**STS-100
FLIGHT READINESS REVIEW**

APRIL 5, 2001

AGENDA	Presenter: Doug White
	Organization/Date: Orbiter/04-05-01

STS-102 RADIATOR FREEZING ISSUE

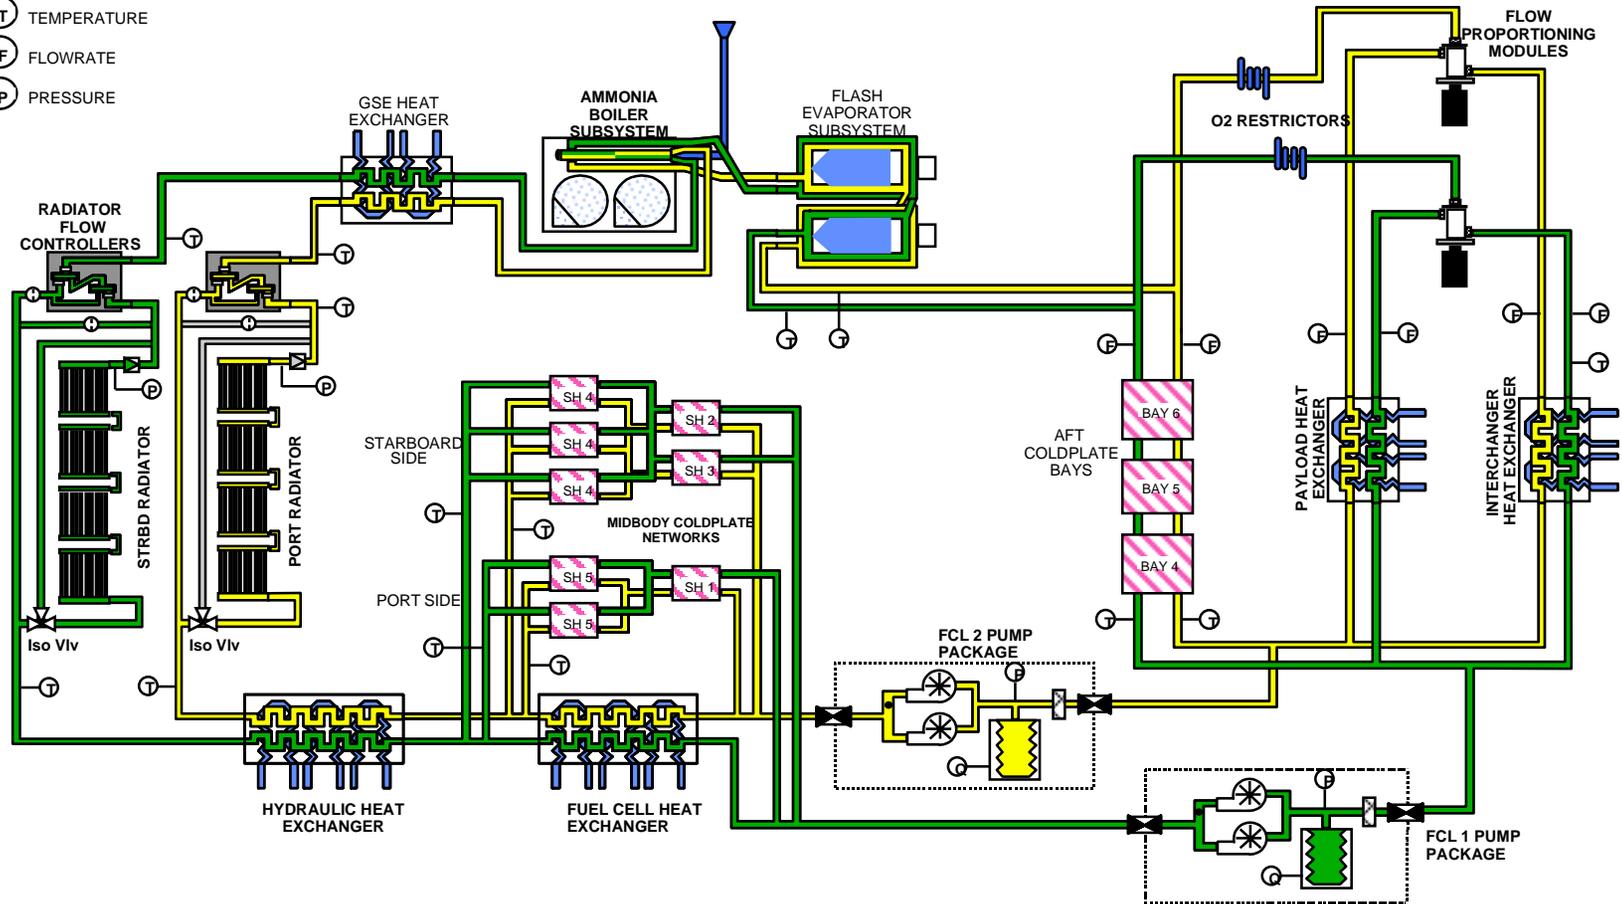
- Freon Loop 1 flow reduction due to icing in Freon, and consequently, flow restriction

- Loss of radiator cooling if unable to remove ice

- Radiator system provides primary vehicle cooling on orbit
 - Consists of four radiator panels and a Radiator Flow Control Assembly (RFCA) per Freon loop
- Flight rule limits the temperature of the freon in the radiators to -85°F to prevent water (15 ppm allowable) from coming out of solution and freezing

Valve Housing and Seat Assembly

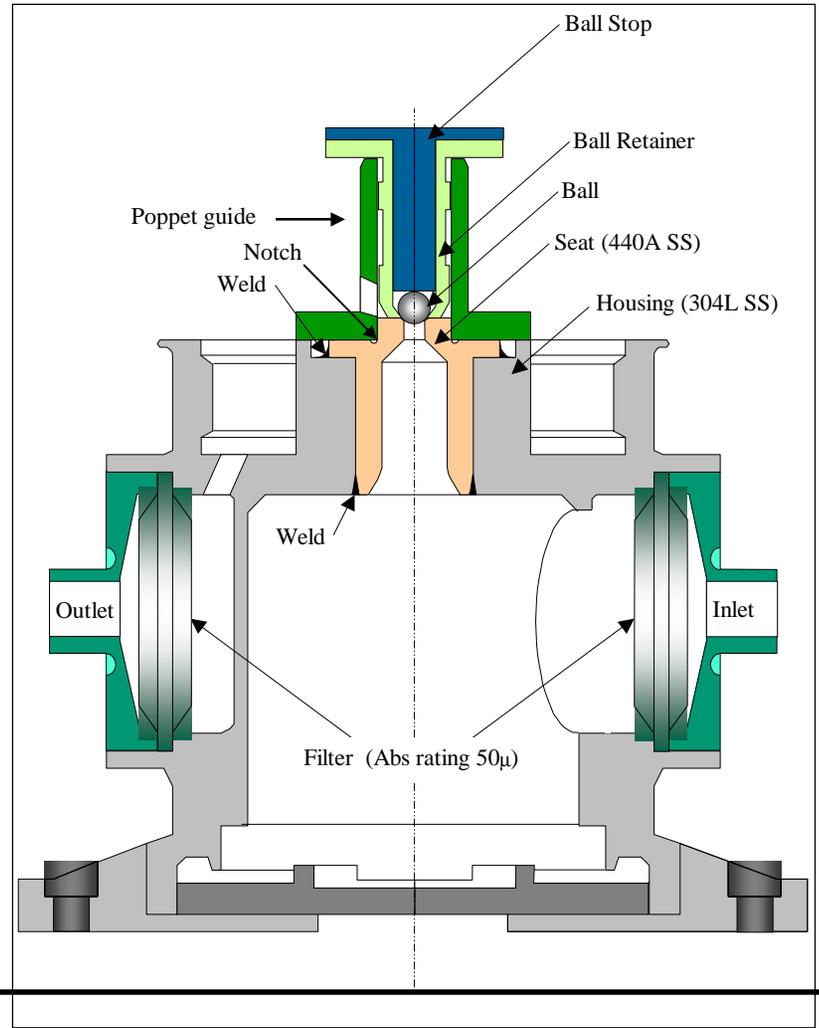
- Visible cracks found on the seat flange of S/N 74 H₂ T-0 valve opened at NSLD for TT&E of an internal leak

- The S/N 74 valve was removed from the panel and cut open for TT&E
- Cracks were visible on the flange of the seat
 - Testing confirmed leakage was through the seat cracks
- Cracks appear to originate at the outer weld and propagate inward toward the notch and then stay in the notch
- Cracks similar to those seen in earlier failed valves

A286, THIN, SELF-LOCKING CASTELLATED NUT

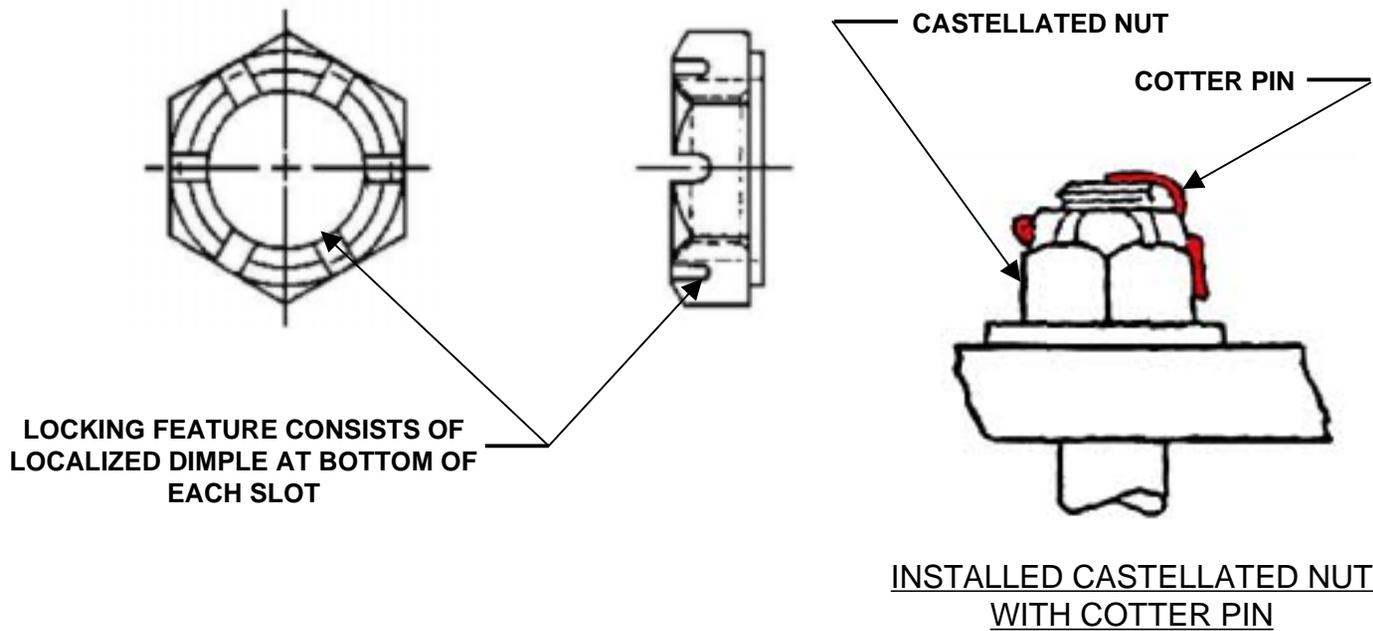
- During installation of the castellated nuts on the remotely operated fluid umbilical (ROFU) mechanism at Palmdale, it was noted that the nuts could be installed (spun down) with little or no resistance
 - Examination of the nuts revealed that the locking feature had worn

- Loss of castellated nut self-locking feature may impact positive retention of nut

White Residue on OV-104 RCC Surfaces

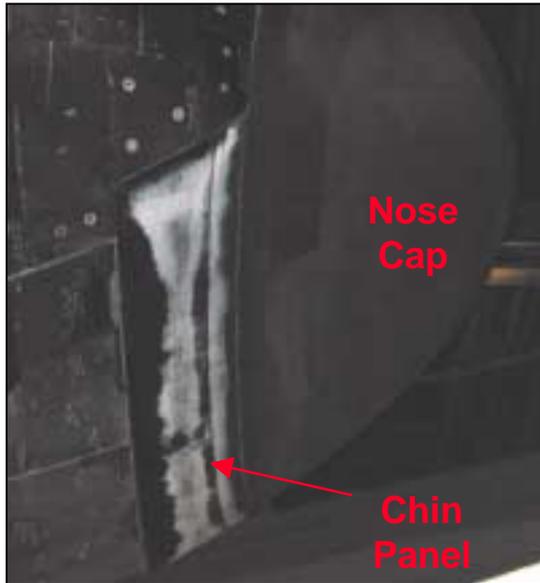
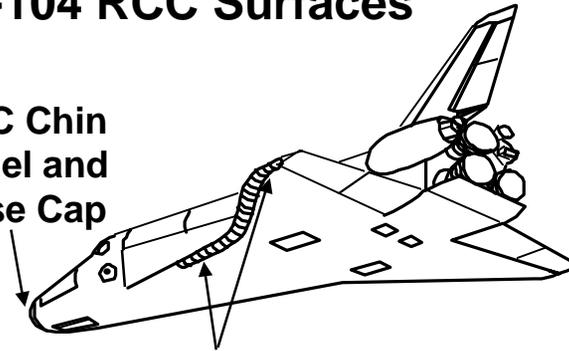
- White residue was seen on OV-104's chin panel and some leading edge RCC panels prior to ferry flight from Dryden following STS-98
- Subsequently white residue was found on OV-102's nose cap and leading edge panels and OV-105's leading edge panels

- Residue may be a contaminant that will adversely affect the RCC, Structure, and TPS
